Subject: Endorsement of NEI White Paper, "Changes to NEI 10-04 and NEI 13-10 Guidance for Identifying and Protecting Digital Assets Associated with the Balance of Plant," dated July 2020, by August 30, 2020

Project Number: 689

1 INTRODUCTION

1.1 PURPOSE

5.1 ~~**(BOP CDAs That Could Cause a Reactor Scram/Trip)**~~

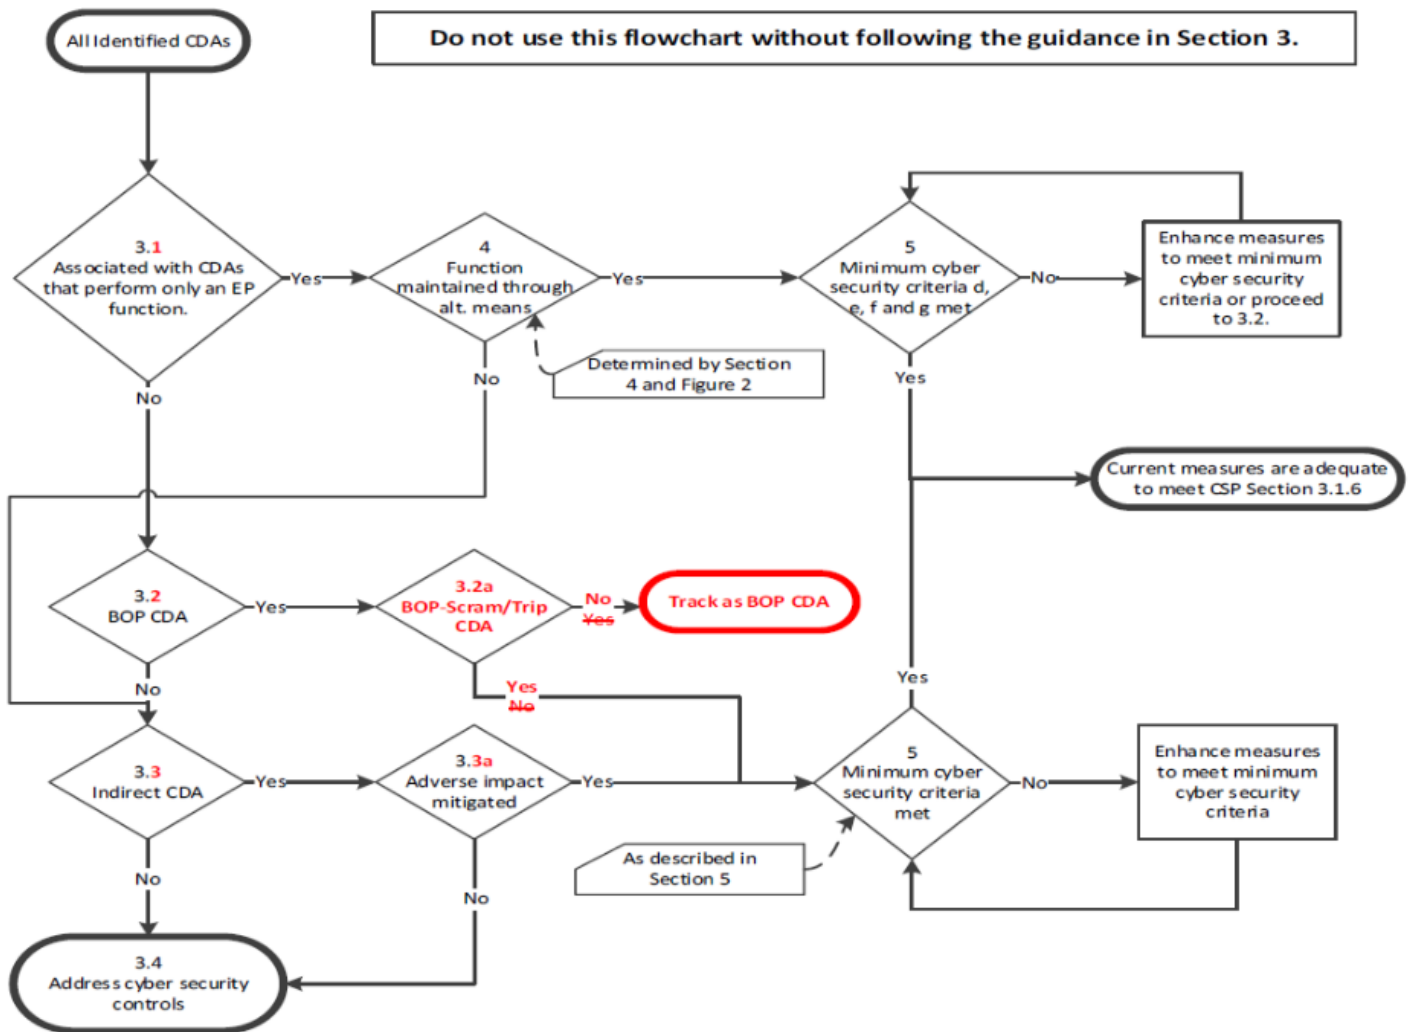
~~For BOP CDAs whose failure or cyber compromise could cause a reactor scram/trip, the following additional security controls from NEI 08-09 Appendix D are implemented where technically feasible (i.e., the CDA supports the technical functionality and features):-~~

~~D.1.2, "Account Management" D.1.6, "Least Privilege"~~

~~D.1.7, "Unsuccessful Login Attempts"~~

Based upon the comparison of the current NERC CIP Standards to the cyber security controls of NEI 13-10, Section 5, Baseline Cyber Security Protection Criteria; the NEI 08-09, Appendix E programmatic controls; and other programmatic processes required by other regulatory requirements for an NPP licensed under 10 CFR 50, the Industry believes the CIP Reliability Standards for MEDIUM and HIGH impact BES Cyber Assets are met as noted above. The current NEI 13-10, Section 5.1 additional controls that were added based upon NERC CIP Standards in 2012 are not needed for the BOP-Scram/Trip CDAs as shown by the comparison above and thus, Section 5.1 can be deleted. The text in Section 5.1 is replaced with “Deleted.”

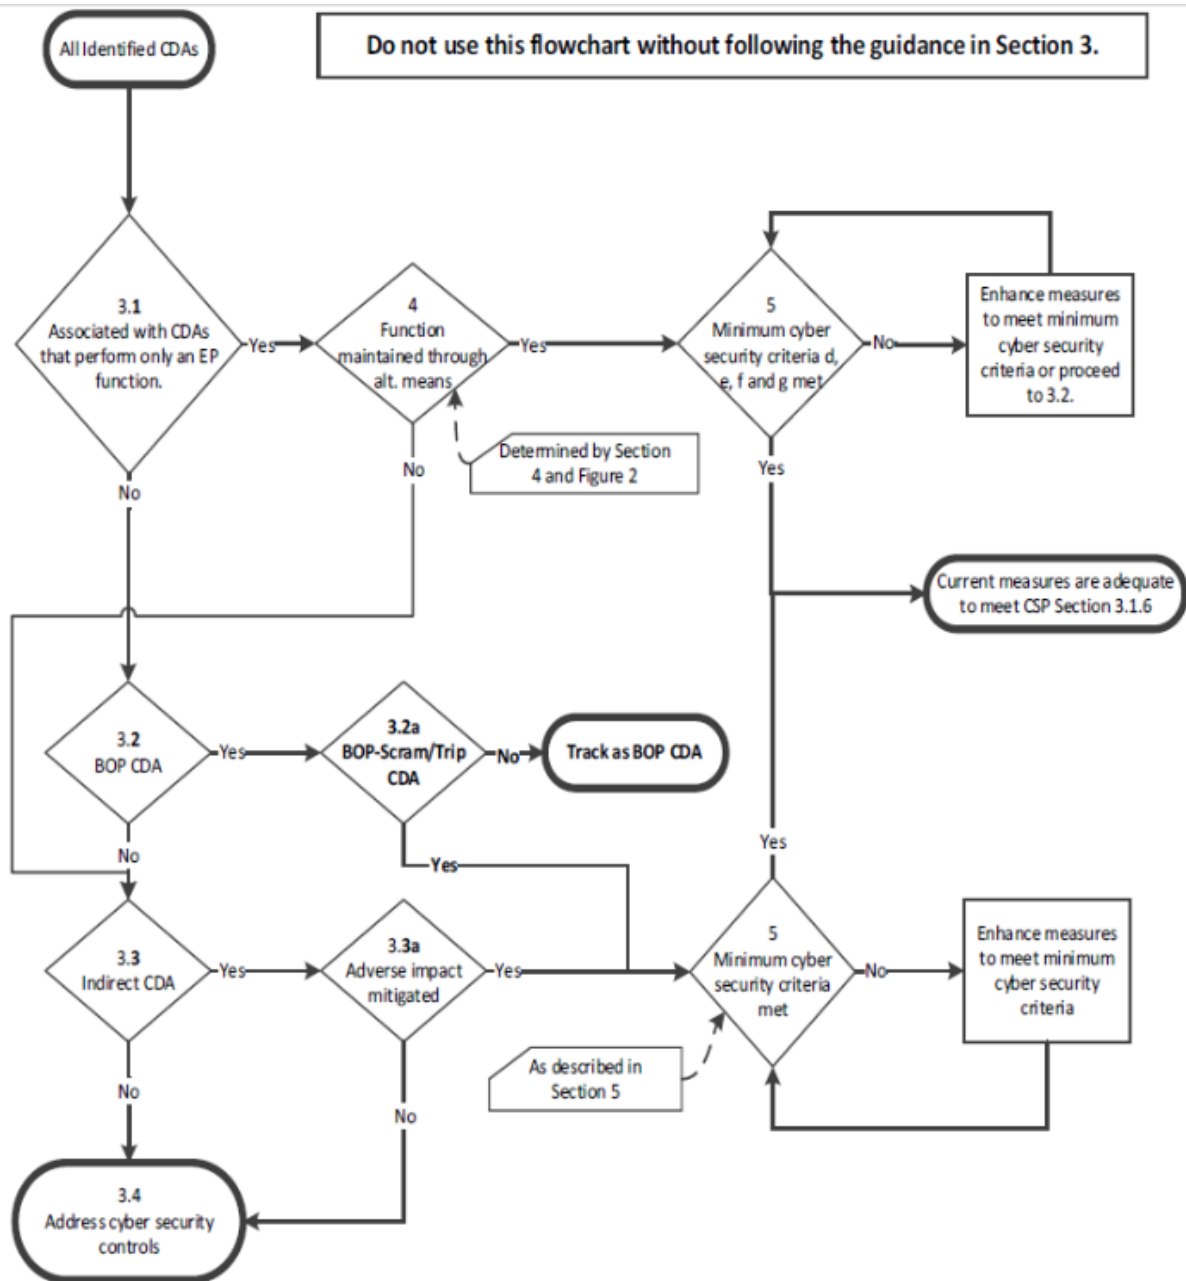
Where a licensee chooses to credit these baseline cyber security controls for an Indirect, BOP-Scram/Trip, or EP CDA, the licensee must confirm these baseline minimum controls criteria are met. EP CDAs may be considered to be adequately protected from cyber attacks if baseline criteria d, e, f, and g are met. A BOP-Scram/Trip CDA or Indirect CDA may be considered to be adequately protected from cyber attacks if all of the following baseline criteria are met:

- a) The CDA, as identified using the analysis set forth in Section 3 of this document, is located within a Protected or Vital Area or the cyber security controls in NEI 08-09, Appendix E, Section E.5 “Physical and Operational Environment Protection,” are addressed.
